**Subject: Proposed Technical Changes
Renewable Energy Approval (No. 6662-8QVM6U)
Burk's Falls East Solar Project**

Northland Power Inc. is proposing to develop and operate a 10-megawatt (MW) solar photovoltaic (Solar PV) facility, on an approximately 80-hectares (ha) parcel of land, located southeast of the intersection of Leggetts Road and Chetwynd Road, in the single tier municipality of Armour Township; herein referred to as "Burk's Fall East Solar Project" or the "Project". The Ministry of the Environment (MOE) issued a Renewable Energy Approval (REA) for the Project (No. 6662-8QVM6U) on February 14, 2012.

Revised Site Plan

PROJECT No.	
TITLE	SOLAR FARM PROJECT SITE PLAN
DRAWING No.	SP-01 (BFE) Rev.P2

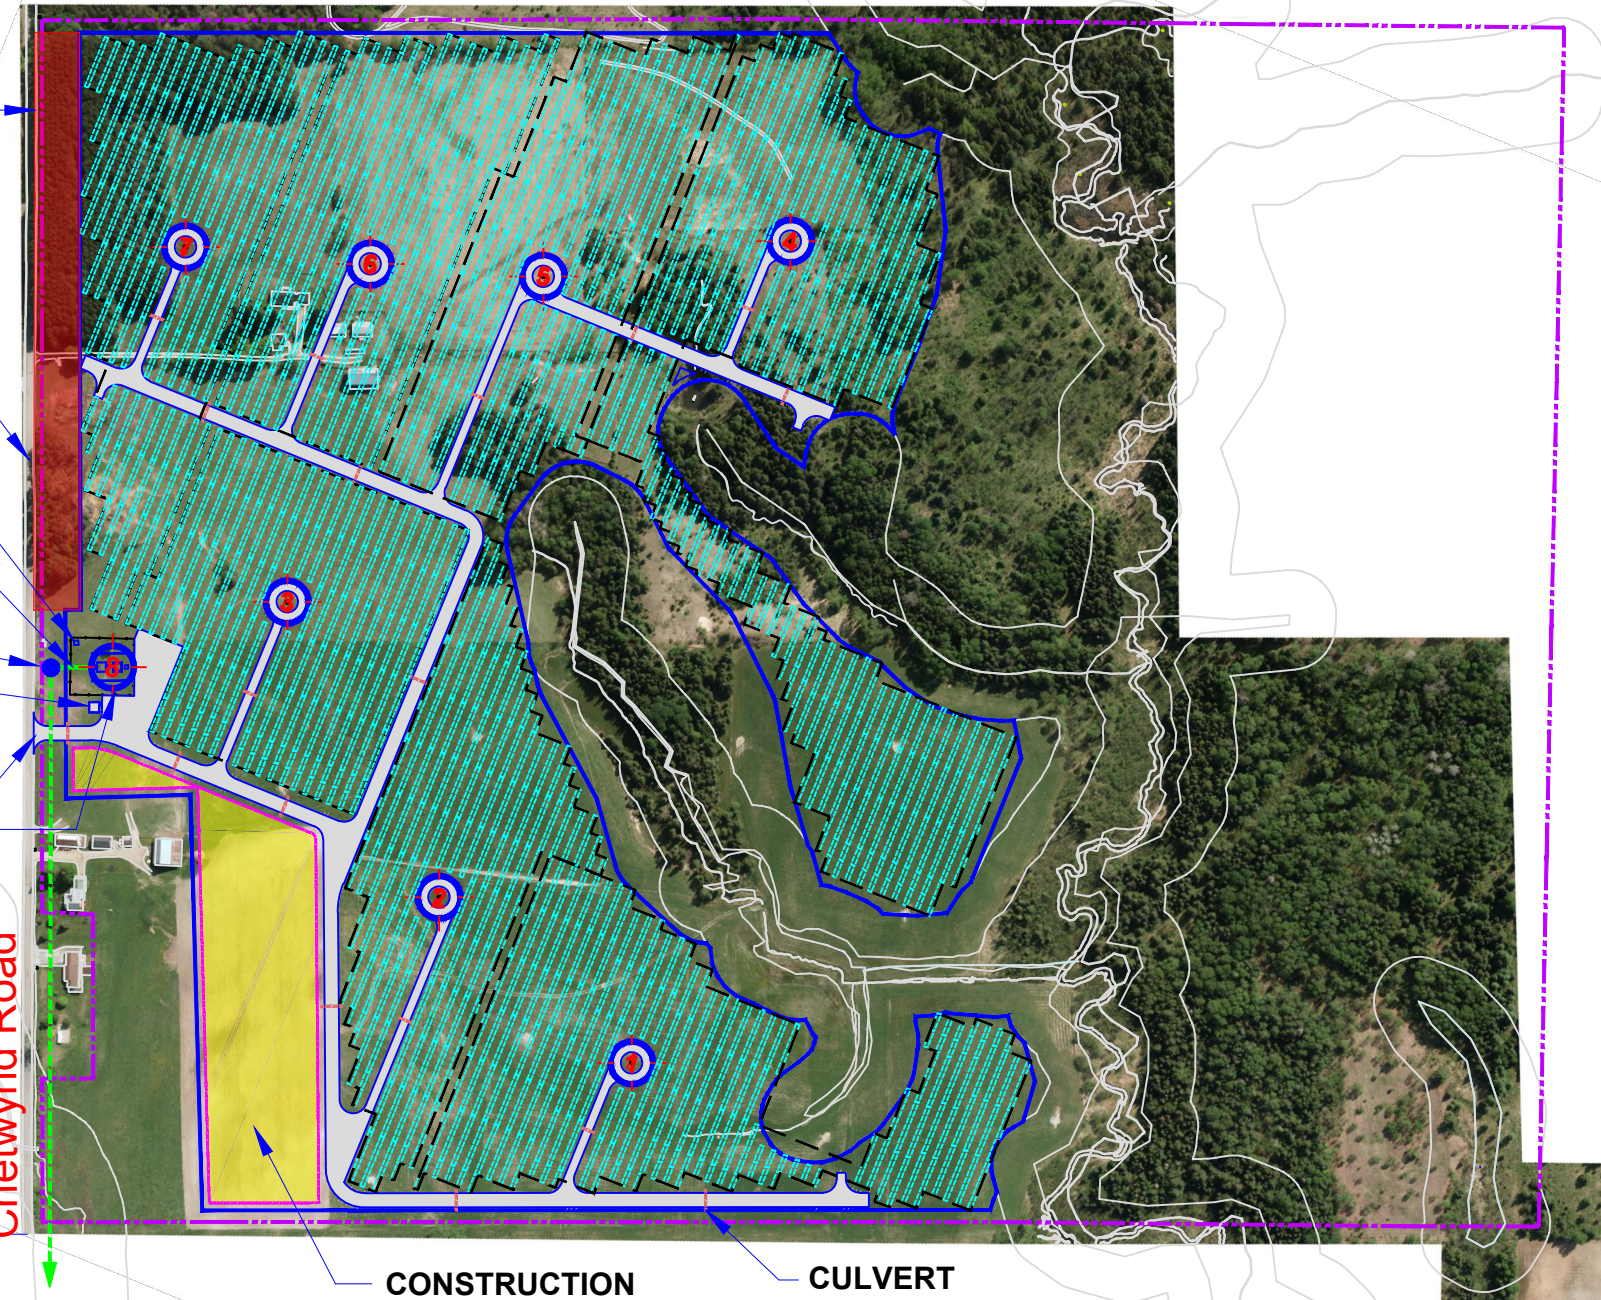
- Removal of trees located along the northern Project boundary, to be replaced by a planted buffer.

The revised site plan is provided in Attachment A.

Change	Change Details	Rationale for Change	Altered Effect	Additional Mitigation Required	Additional Environmental Effects Monitoring
Tree Removal	Tree removal along the northern boundary	It was determined that the rooting for these trees is unstable and could cause harm to either the workers or Project materials if they were to fall	The removal of the trees will result in an increased visual presence of the facility along Chetwynd Road	A buffer of shrubs and trees will be planted	None required

Page	Section	Original Text	Amended Text
10	2.3.1.2	The proposed Project land has woodlands located on the property. A portion of the woodland will be cleared in order to install PV modules and avoid shading or blocking the sun on the PV panels.	The proposed Project land has woodlands located on the property. A portion of the woodland will be cleared in order to install PV modules and avoid shading or blocking the sun on the PV panels. Further a portion of the northern woodland will be removed to eliminate any potential harm from falling trees. Trees removed along the northern extent of the site adjacent to Chetwynd Road will be replaced by a planted buffer.
29	Appendix A	Original Site Plan	See attached revised site plan (Attachment A).

Page	Section	Original Text	Amended Text
13	Table 5.1	Visual barriers will be considered, if necessary, and will be reviewed based on viability and effectiveness.	Visual barriers, in the form of a planted buffer will replace the removed vegetation located along the northern extent of the site adjacent to Chetwynd Road. Additional visual barriers will be considered, if necessary, and will be reviewed based on viability and effectiveness
21	Appendix A	Original Site Plan	See attached revised site plan (Attachment A).

ISSUED FOR TENDER	
PROJECT No.	
TITLE	SOLAR FARM PROJECT SITE PLAN
DRAWING No.	SP-01 (BFE) Rev.P2

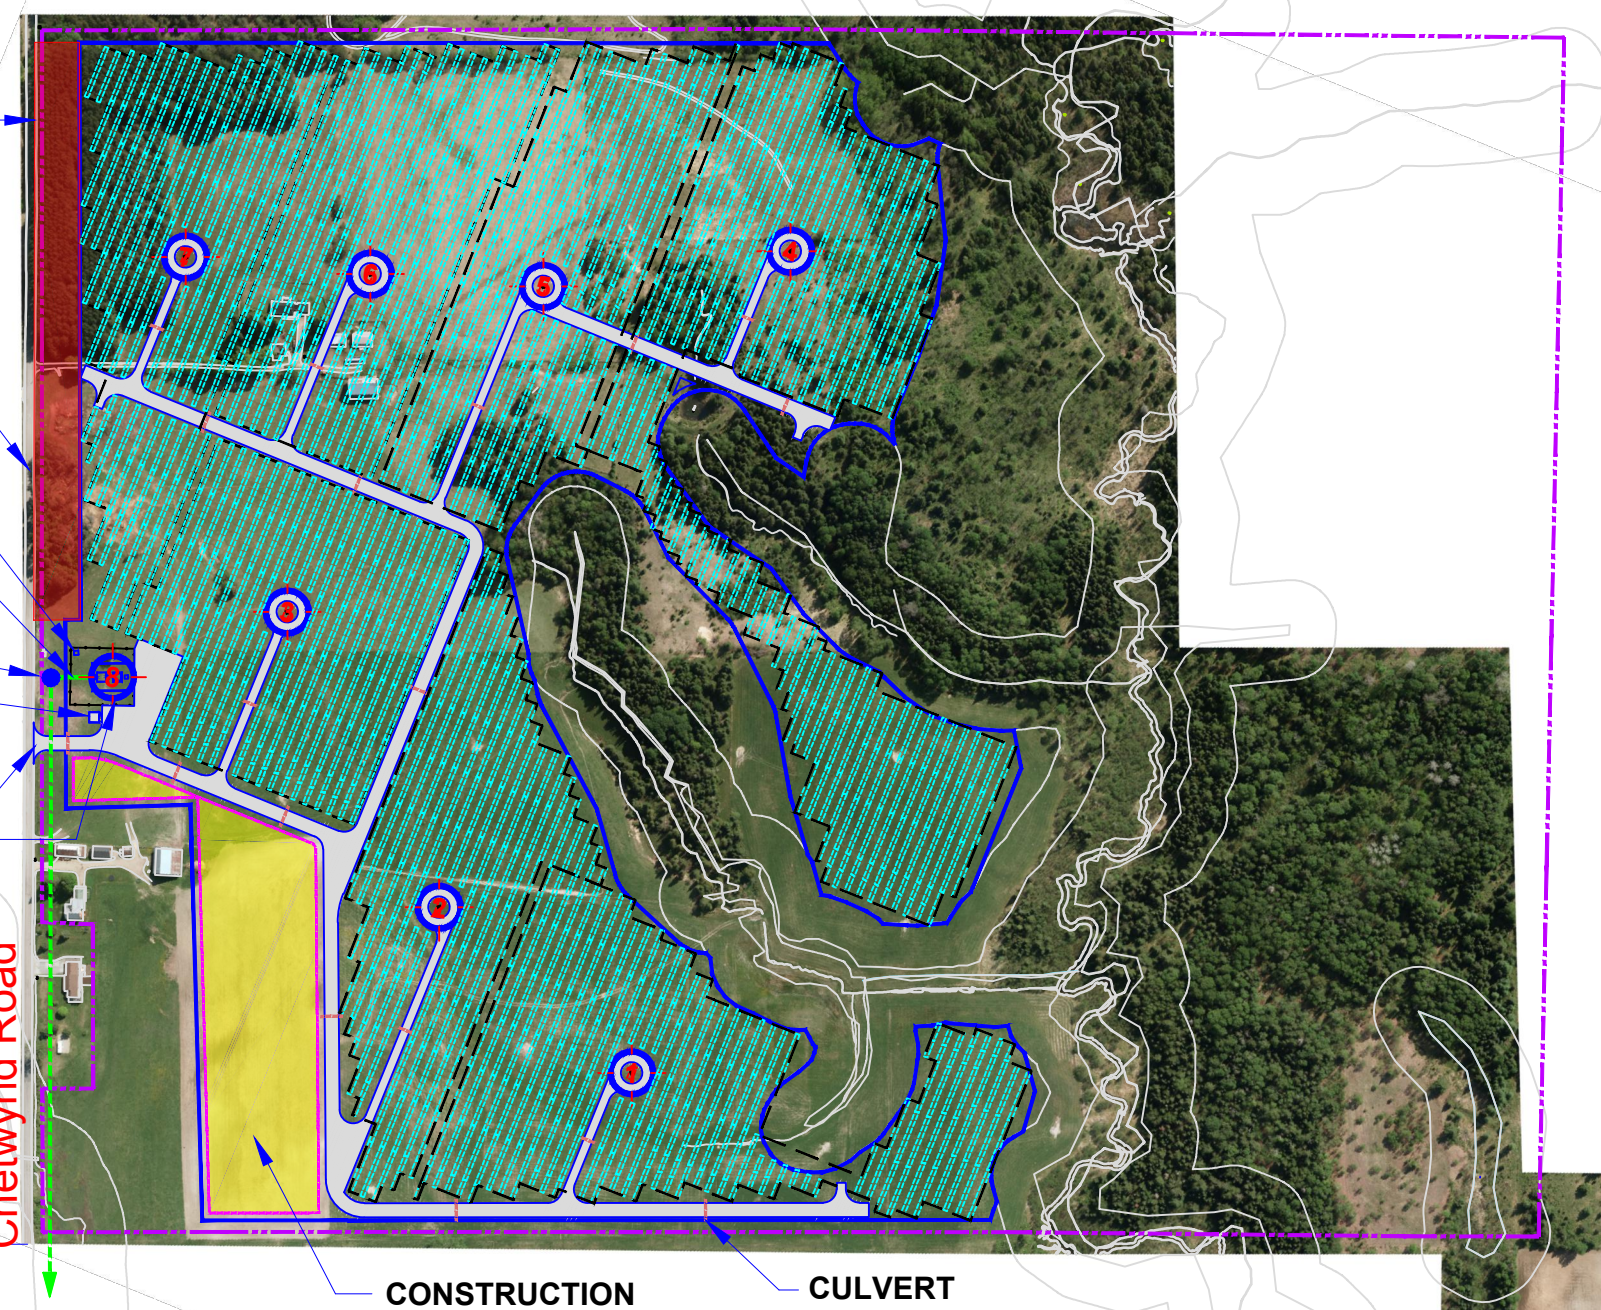
This notice is provided to make you aware that Northland Power Solar Burk's Falls East L.P. is applying to the MOE for an amendment to the REA. This amendment is being made as it is necessary to remove the trees from the northern portion of the Project as they are in poor condition and could cause harm to construction workers, Project components as well as the public due to their proximity to Chetwynd Road. Any removed trees will be replaced with a planted visual buffer. A revised site layout is attached displaying the tree removal area.
